PHILIP A. MERTEN AIA ARCHITECT

Re: December 4, 2025 - Planning Commission Hearing
Item No. 1
8303 La Jolla Shores Drive - CIELO MAR
Project No. 1085883

**Re: Planning Commission Hearing December 4, 2025 – 8303 La Jolla Shores Drive
Project (PRJ-1085883) – Drainage System and Easement Issues Along Calle
Frescota**

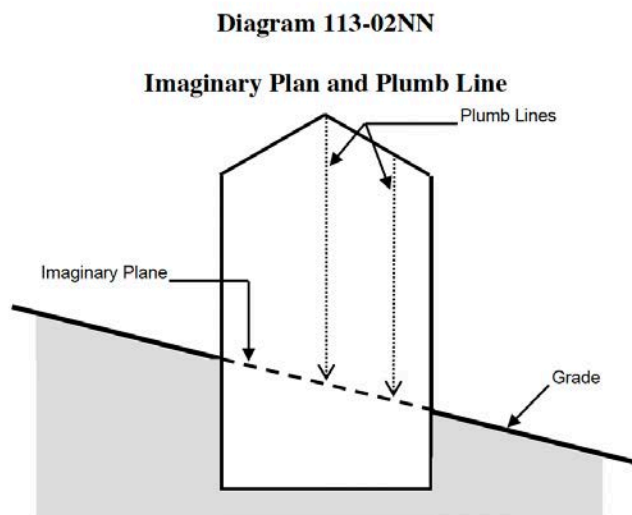
Contrary to the 30 foot Plumb Line Structure Height limitation, the proposed Plumb Line Structure Height of the proposed dwelling on Lot 2 as depicted on submittal drawings posted at <https://www.sandiego.gov/sites/default/files/2025-04/cielo-mar-combined.pdf> is **34'- 6 3/4"** as clearly shown on the LOT 2 -WEST ELEVATION on Dwg. No. A404.
